Regulatory Affairs & Vigilance Department  
Toshiba Medical Systems Corporation

18-June-2016

### **Notice regarding modification to diagnostic ultrasound systems TUS-X200/X200S and TUS-X100**

<Figure> Display of error message

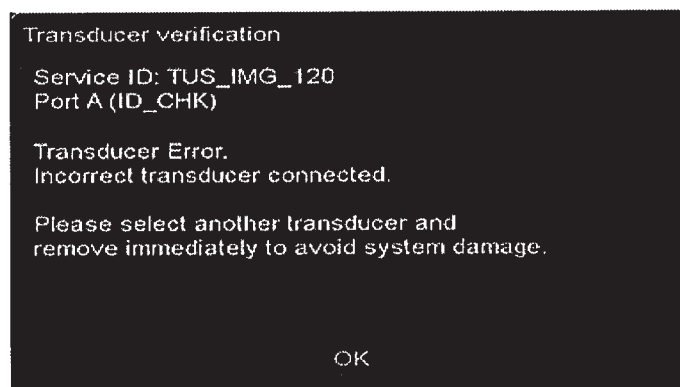
For the systems specified in section 1, an error message may be displayed due to the occurrence of a software error when a transducer is disconnected and reconnected, a transducer is changed, or another transducer is selected.

It has been found that when the following error message is displayed and the system continues to be used, the surface of the acoustic lens of the transducer may become hot, which can result in moderate burns if the transducer is used on one area of the patient's body for a long time.

If the error message shown in section 3 is displayed before the modification has been performed, immediately stop using the system and perform the procedure described in steps 1) to 4) below to check the problem.

For the problem described above, software containing corrective measures will be installed as modification support.

- 1) Shut down the system by pressing the power button .
- 2) After the system power is completely turned OFF, disconnect and reconnect the transducers.
- 3) Start up the system by pressing the power button .
- 4) After startup of the system is completed, press the transducer selection button  and select all transducers that are currently connected to the connector ports.

The system can be used with no problem if the error message shown in figure 2 is not displayed. If the error message is displayed again even after performing the procedure described in steps 1) to 4), it is likely that the system or the transducers are faulty. In this case, contact your service representative.
